NOTICE OF VIOLATION

On July 17, 2025, Energy Safety conducted an inspection of PG&E's WMP initiatives in the vicinity of the city of Novato in High Fire Threat District (HFTD) Tier 3, California. The inspection report is enclosed herewith. Energy Safety found the following violation:

INSPECTION REPORT

Item1GImg1: Pole ID 120511951.

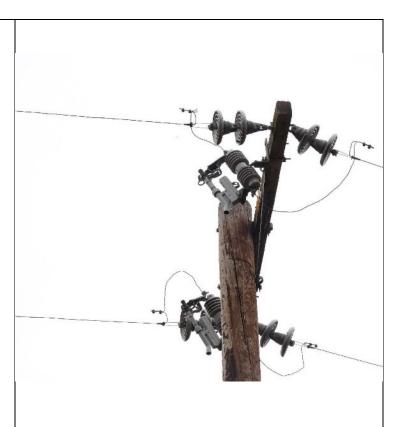
At pole ID 120511951, near GPS coordinates 38.085315291612744, -122.591955114665, PG&E reported the completion of mechanical pole clearing on December 15, 2024, in the 2025 Q1 QDR data. However, the inspector observed that PG&E failed to adhere to its protocol of maintaining the required radial firebreak distance of 10 feet around the base of the pole. Dry vegetation was present from the base of the pole radiating in each direction within 10 feet. Additionally, the pole is located in HFTD Tier 3 within an SRA and is equipped with non-exempt split bolt connectors. Therefore, it falls under the requirement of PRC 4292, which mandates the removal of flammable vegetation within 10 feet of such poles. The inspector's observation is documented in Violation 1 photographs, which are attachments to this report. Photo numbers Item1GImg1 and 1GImg2 depict pole ID 120511951 and an overall view of the equipment on the pole. Photo numbers Item1IA1Img1 and Item1IA1Img2 show the non-exempt split bolts on the pole. Photo numbers Item1IA1Img3 and Item1IA1Img4 depict vegetation present within 10 feet of the pole.
